Product / Process Change Notification (PCN)

PCN #: PCN_SwTASU_20210430
Affected Series: 434 35x 045 816, 434 33x 045 822
 436 35x 045 816, 436 33x 045 822

PCN Date: January 29, 2021
Effective Date: April 30, 2021

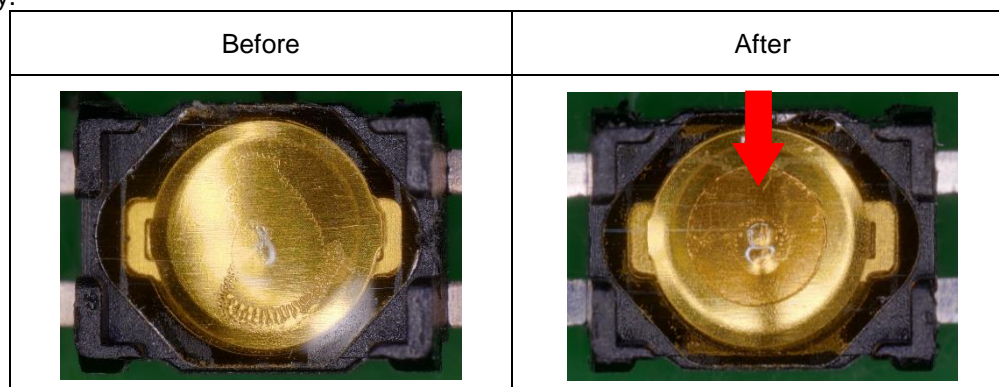
In order to enhance the product reliability, Würth Elektronik will change the process at assembly station and improve the product design.

The additional mylar to be added between Dome and top mylar. With double mylar, the product is enhanced its reliability.
